**Further Measures to Preserve Trees and New Measures to Create Greenery
in the Jingu Gaien District Urban Redevelopment Project
(Supplementary Materials)**

This document provides supplementary materials to the following release dated on the same day.

Figure 1 New rugby facility site - Location of reclassified trees and facility design changes

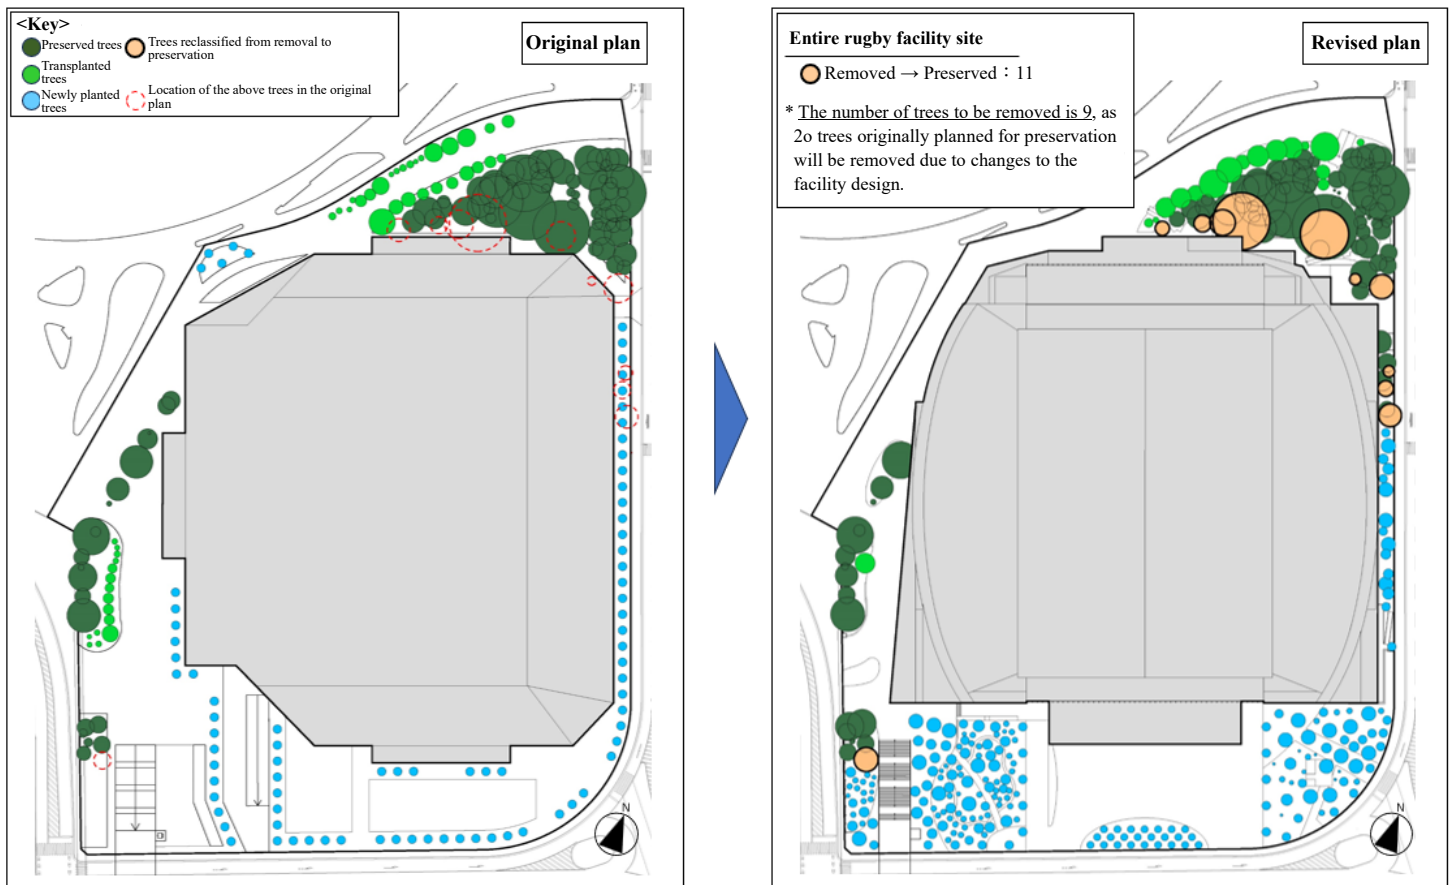
By setting back part of the northern section of the new rugby facility, 9 trees for removal at the Kenkoku Kinen Bunko site will be preserved (Figure 1).

To improve the growing environment for trees around the new rugby facility, the height of the building will be reduced from approximately 55.0 meters in the original plan to around 48.0 meters.

Figure 7: Simplified diagram of the root system protection area and the setback width to the underground framework for the baseball stadium

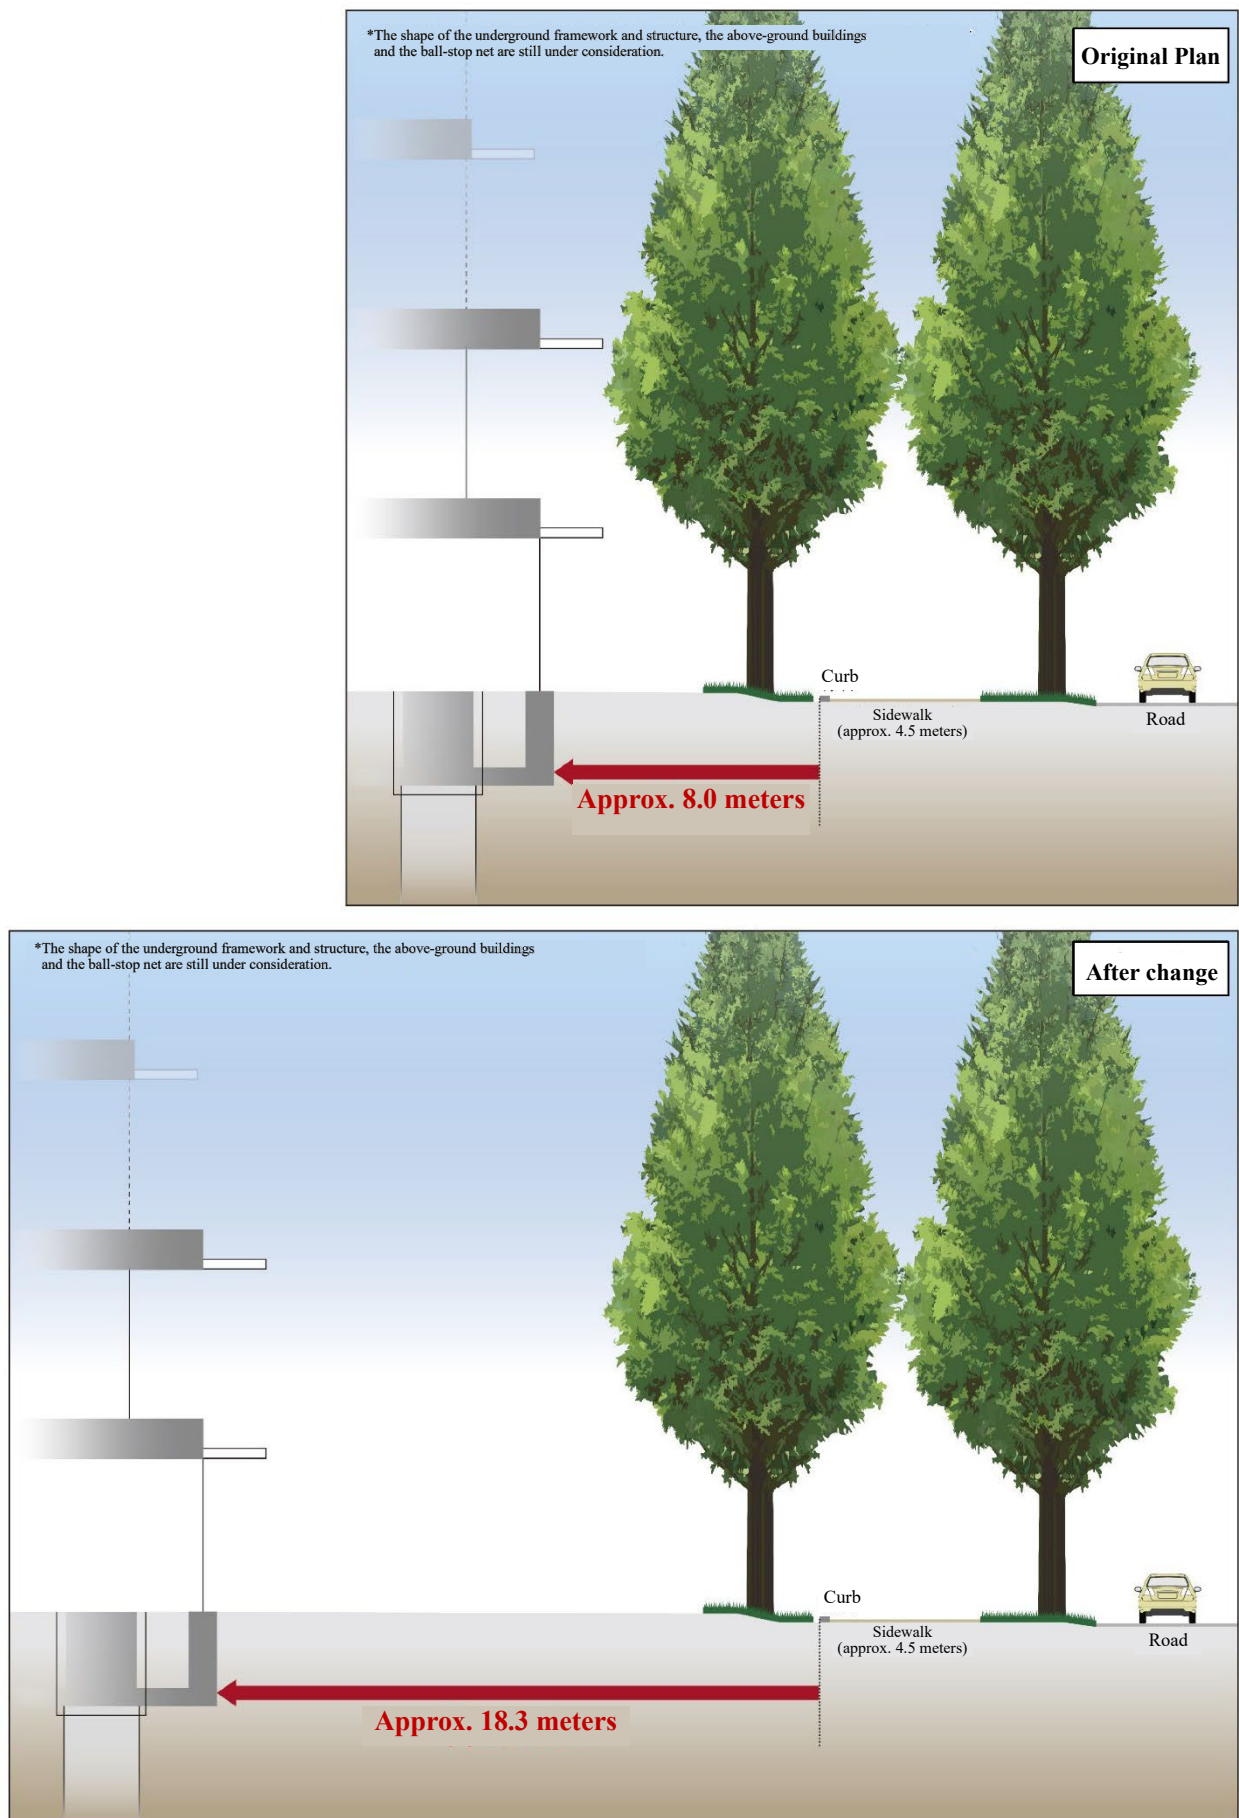
approximately 30 millimeters were identified at **four*** of the 12 survey sites. The five roots were identified to their tips using lateral digging^{*14}. This confirmed that two had stopped growing at a distance of less than approximately 17.0 meters, two were assumed to not be growing to the west, and one had grown to approximately 22.0 meters but was less than 30 millimeters in diameter at approximately 17.0 meters. Under the criteria for making judgements in the environmental impact assessment report, it would be acceptable to cut these roots at a distance of around 10.5 meters. However, after conducting lateral digging and obtaining the opinions of tree doctors and other experts, we decided to set the root system protection area at approximately 17.0 meters from the sidewalk curb. Also, to secure an additional 1.3 meters of space during construction and to provide additional space for root system growth, the setback width has been extended from approximately 8.0 meters in the original plan to approximately 18.3 meters (Figure 7).
